<b>Well Name:</b> CANDADO	<b>Well Location:</b> T26N / R7W / SEC 4 / NENE / 36.518646 / -107.574631	<b>County or Parish/State:</b> RIO ARRIBA / NM
<b>Well Number:</b> 8	<b>Type of Well:</b> CONVENTIONAL GAS WELL	<b>Allottee or Tribe Name:</b>
<b>Lease Number:</b> NMSF079161	<b>Unit or CA Name:</b>	<b>Unit or CA Number:</b>
<b>US Well Number:</b> 300390673100S1	<b>Well Status:</b> Gas Well Shut In	<b>Operator:</b> EPIC ENERGY LLC

**Notice of Intent**

<b>Type of Submission:</b> Notice of Intent	<b>Type of Action</b> Plug and Abandonment
<b>Date Sundry Submitted:</b> 05/04/2021	<b>Time Sundry Submitted:</b> 10:50
<b>Date proposed operation will begin:</b> 05/14/2021	
<b>Procedure Description:</b> resubmittal of due to WIS to AFMISS

**P&A Procedure**  
**EPIC Energy – Candado #8**

Proposed P&A

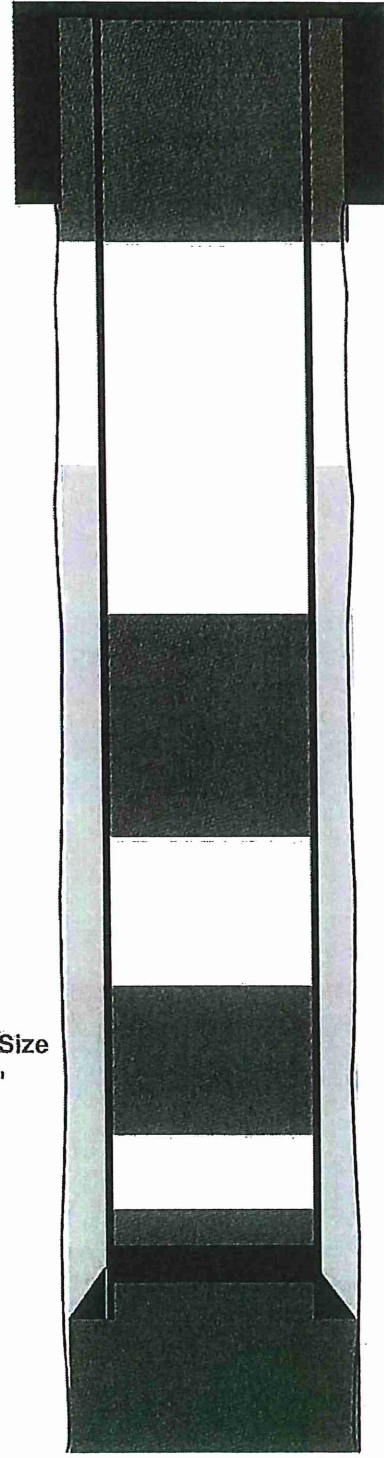
- a) Additional cement may be required for Plug 2 and Plug 3. Before starting work, confirm cement volumes with the BLM inspector to ensure cement is adequate.
- b) Adjust Plug #3 to cover the interval from 1896 ft. to 2269 ft., the formations tops of Ojo Alamo and Kirtland.
- c) Add an additional plug to cover a minimum of 50 ft. below and above the top of the Nacimiento formation at 701 ft. This may be an inside/ outside plug or balance plug depending on the CBL results.
- d) Bring the bottom of the Surface Plug down to 50 ft. below surface casing shoe. (approximately 140'). Perforate also at this depth to circulate cement to surface.

- BLM formation top picks for the Nacimiento, Ojo Alamo, and Kirtland formations vary from operator picks.
- Adjust Plug #3 (Ojo Alamo and Kirtland) to cover the interval from 1896'-2269' to cover BLM formation top picks.
- Add a plug to cover the Nacimiento formation top @ 701'.
- Log analysis of reference well #2 indicates the Nacimiento and Ojo Alamo sands investigated likely contain fresh water ( $\leq 5,000$  ppm TDS). By adjusting the plugs as described above, fresh water sands in this well bore will be protected.
- Pictured Cliffs perforations @ 2837'-2912'.
